ADDENDUM NO. 1

City of Greenfield
Waterview Lift Station Relocation Project

WATERVIEW LIFT STATION RELOCATION PROJECT CITY OF GREENFIELD, INDIANA AMERICAN STRUCTUREPOINT PROJECT No. 2021.02592

JUNE 21, 2024

C-112

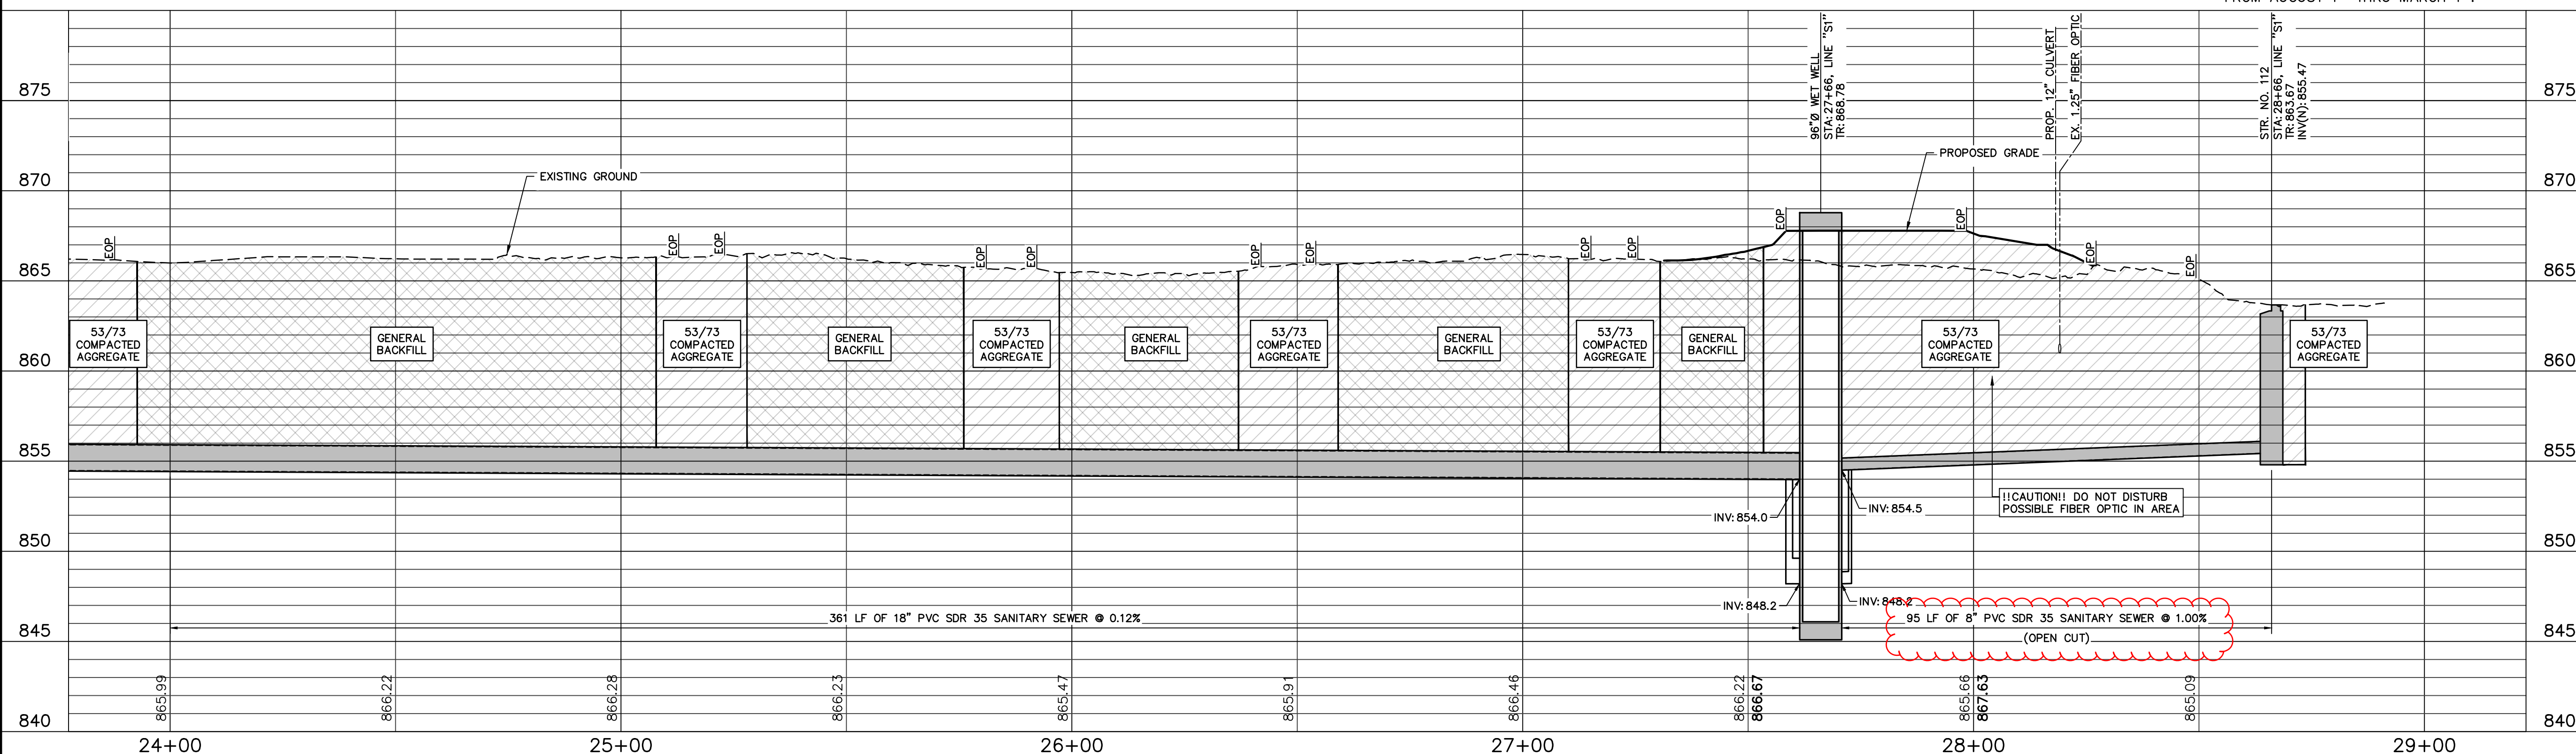
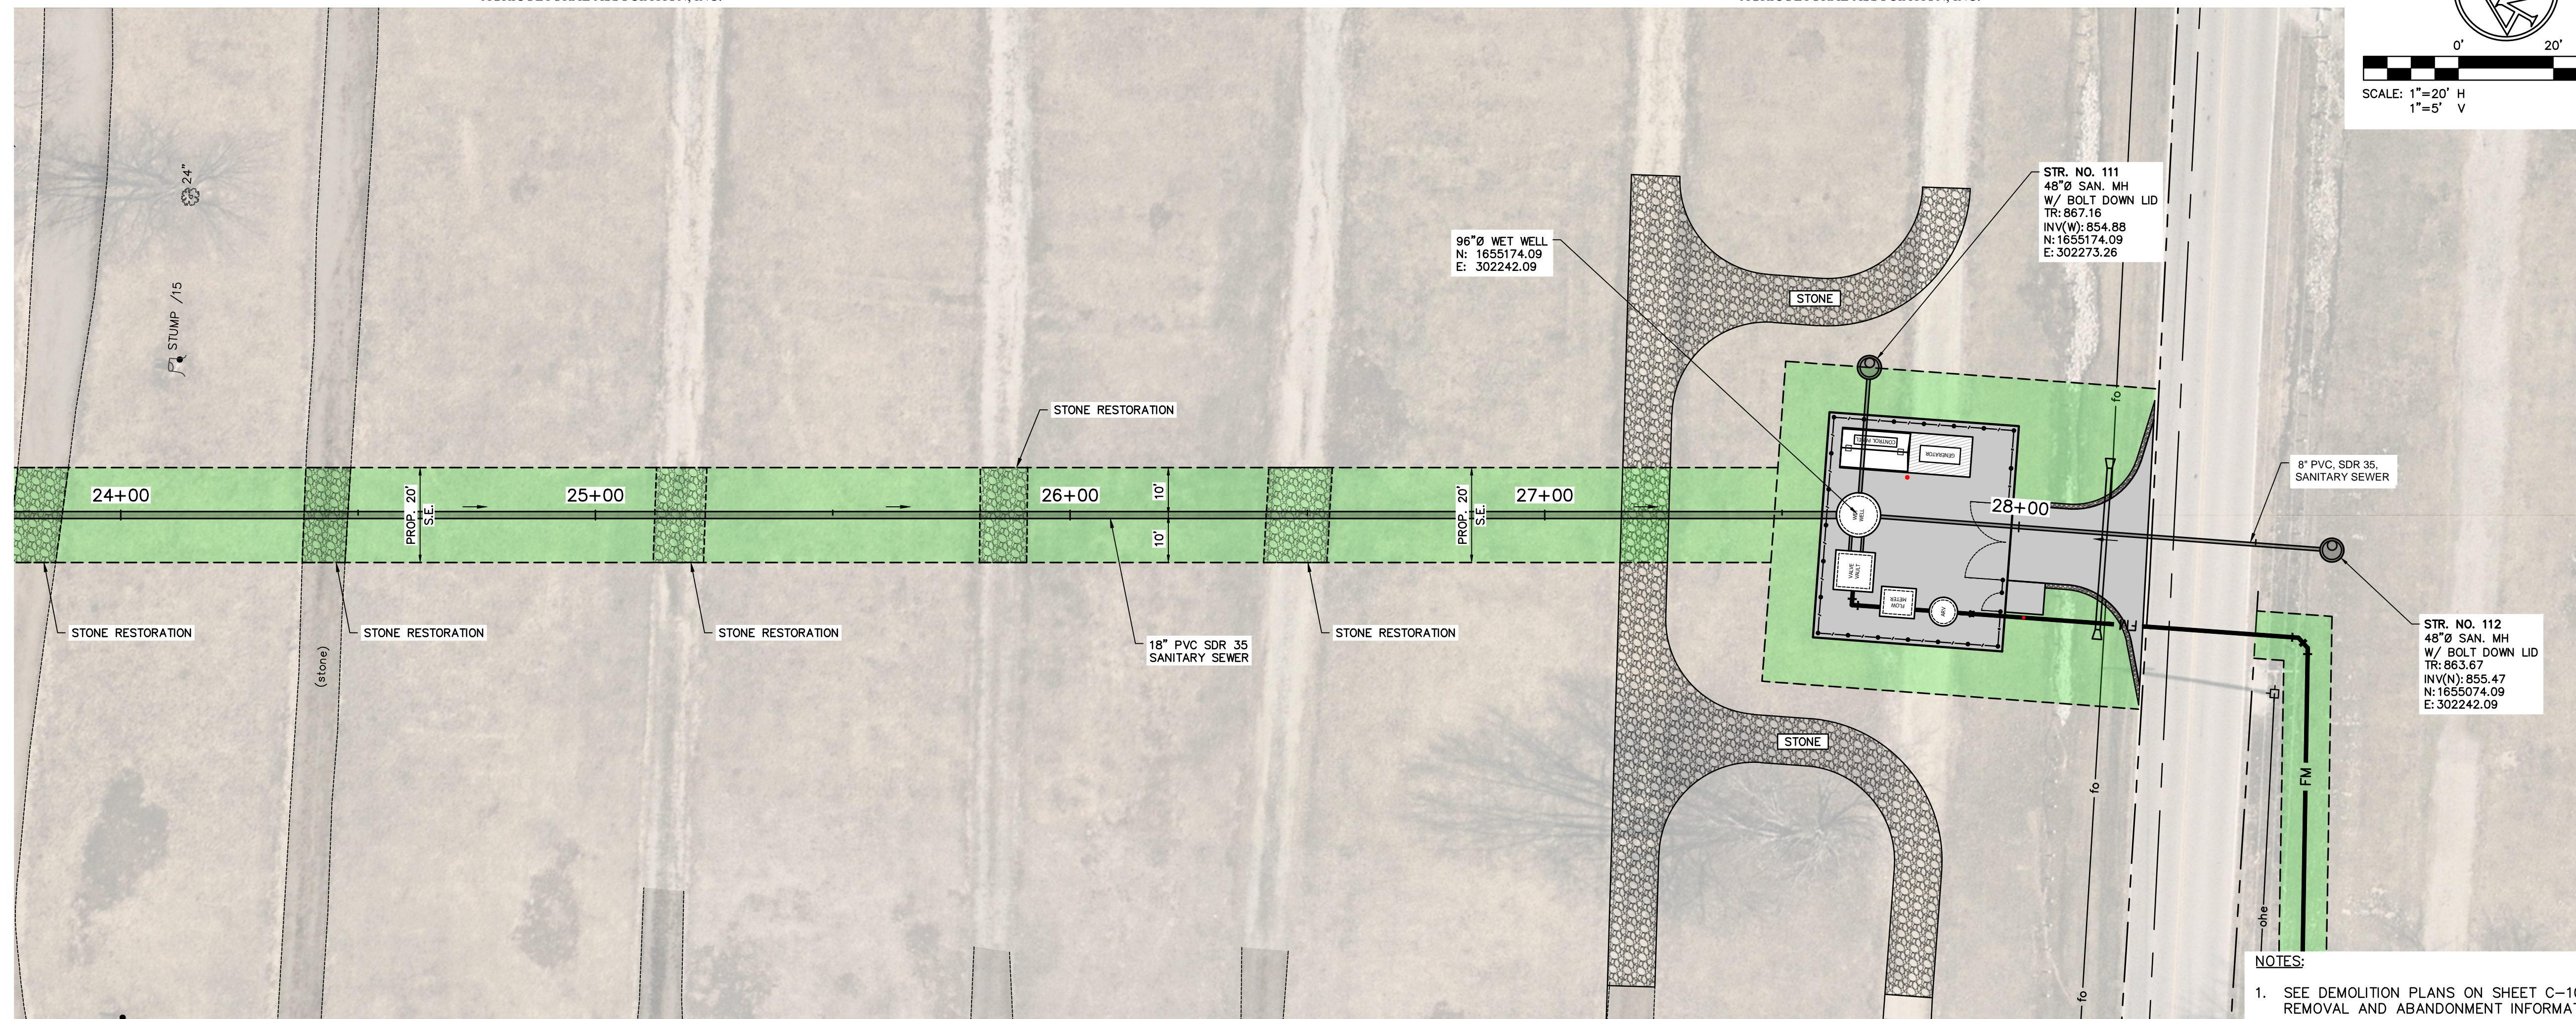
1. Replace sheet C112. Replace 8" HDPE directionally drilled pipe with 8" PVC SDR 35 (open cut).
